Published by:  
Service Department LOBPA Hong Kong

LINE OF BUSINESS PORTABLE AUDIO

# SERVICE NEWSLETTER

**03.01** TYPENUMBER(S): **AS445**

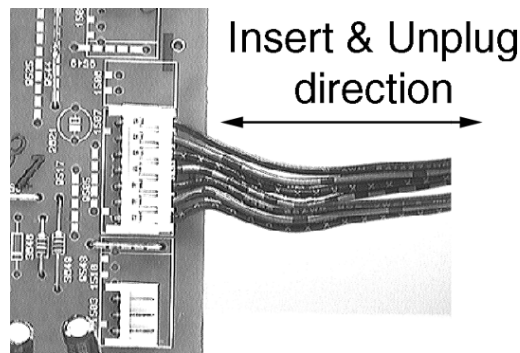
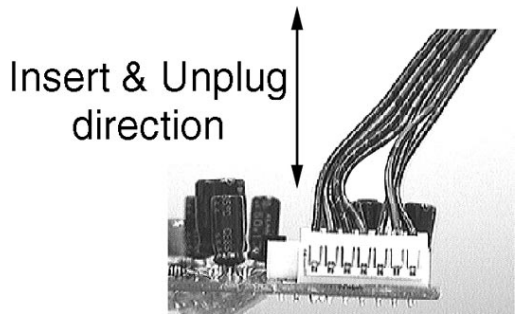
- SYMPTOM** : The message "HELLO" is shown on the display.
- CURE** : This phenomenon only appears when the mains cable is connected to the set, i.e. when moving the set to another place.  
The message automatically disappears after a few seconds, when the set switches into the standby-mode.
- REMARKS** :

**03.02** TYPENUMBER(S): **AS660C, AS665C, AS760C, AS765C, FW322C, FW332C, FW335C, FW340C, FW342C, FW345C, FW352C, FW372C, FW362, FW363, FW373C, FW382V, FW391C, FW392C, FW395C, M7C, M17C, M27C, MC130, MC150, MC170, MX545**

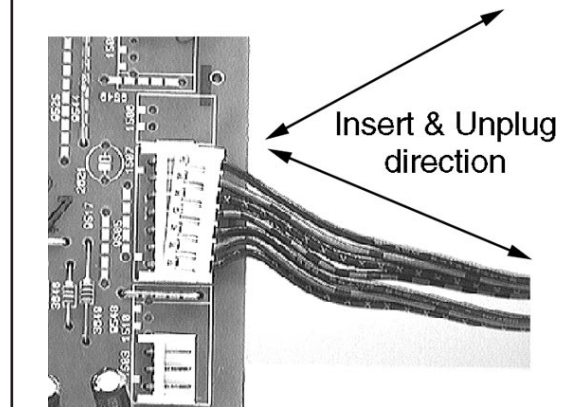
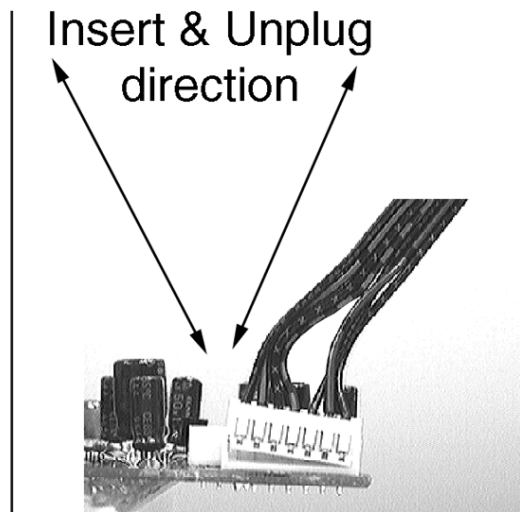
- SYMPTOM** : Various failures disappear when the set is opened or when connectors are reconnected.
- CAUSE** : During production some JST connectors were changed from XH type to EH type with smaller head. This new EH type is more fragile and susceptible to deformation during plugging in and out of the connector socket. When it is deformed it will result in poor or intermittent contact.
- CURE** :  
1. During repair service technicians must handle the EH type connectors with care. The correct way to plug it in and out is indicated below.  
2. All EH type connectors with an intermittent contact should be replaced as a preventive action.  
3. All the different wire assemblies had been standardized and are available under the following service codes. For repair application the wires should be cut to the correct length as required in the defective set.

Order code	Description
4822 232 10395	6 pins Connector wire
4822 323 10396	5 pins Connector wire
4822 323 10405	4 + 3 pins Connector wire
4822 323 10397	4 + 5 pins Connector wire
4822 323 10398	6 + 4 pins Connector wire
4822 323 10399	4 + 4 pins Connector wire

**02.10 TYPENUMBER(S): FW362, FW372C**

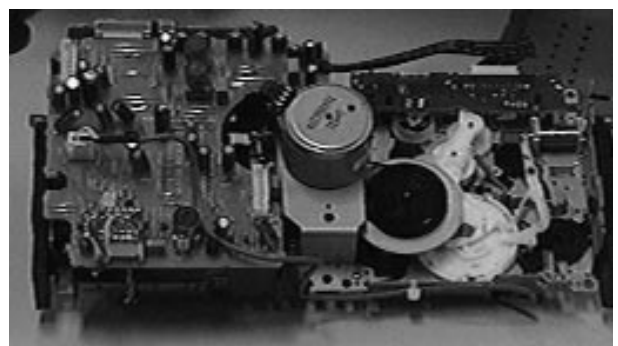
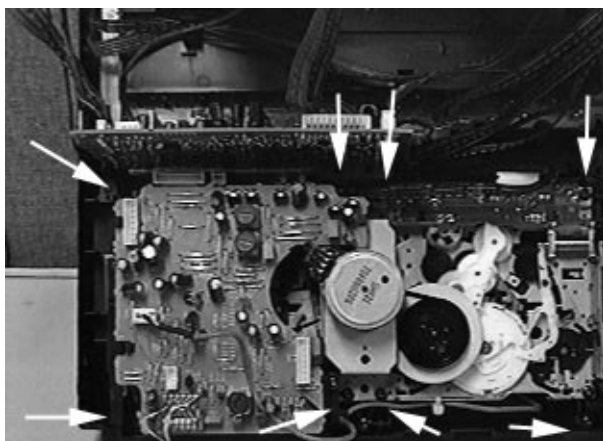
- 1) First remove the top cabinet of the set.
- 2) CD Shortloader Module:  
Loosen the 2 screws indicated in the picture above.
- CD Changer Module:  
Loosen the 2 screws at the back panel & the 2 screws on the front tray of the CDC module.
- 3) Remove the CD module.

- 4) Turn the set aside and loosen the bottom screw as indicated in the picture above.
- 5) Detach the front panel from the bottom panel.

- 6) Loosen the 8 screws of the tape module as indicated in the picture above  
(Note: 4 short screws on top, 4 long screws below).
- 7) Release all wires of the tape module.
- 8) Slowly detach the tape module from the cassette door.
